PLANNING STATEMENT

47-49 PERCY STREET, BANKSTOWN

S4.55(2) MODIFICATION APPLICATION

PREPARED FOR TQM Design & Construct

Figure 13 Roof terrace landscape details (Source: Site Image)

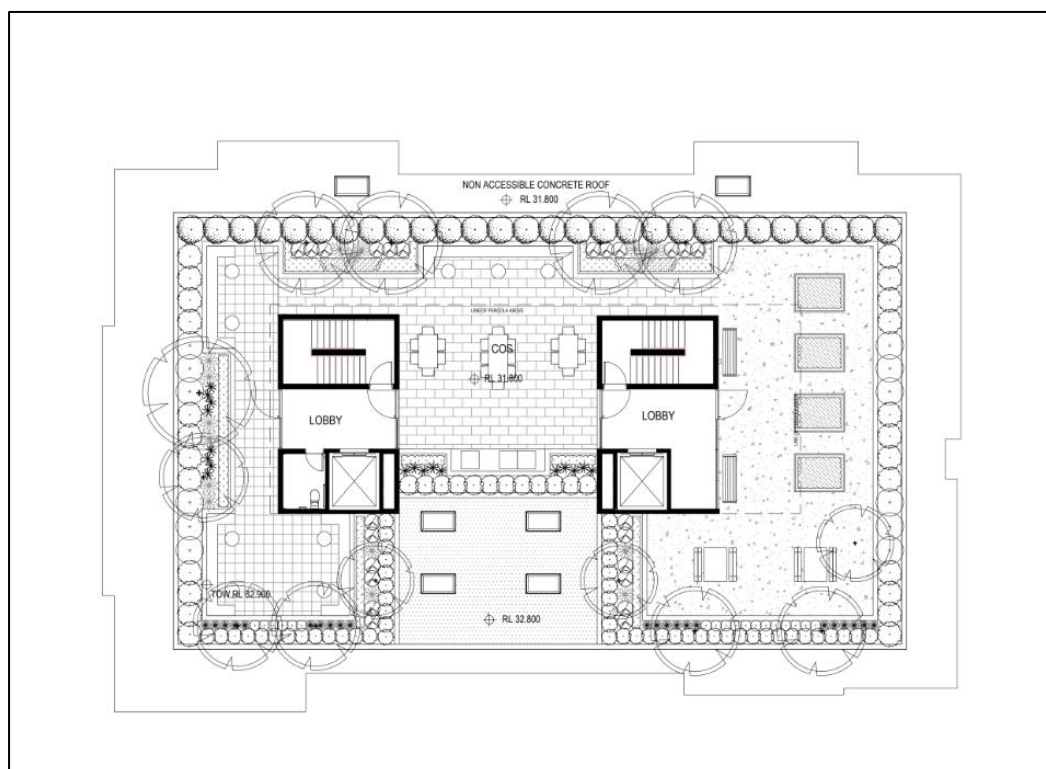
- Addition of COS 293.1sqm and BBQ area
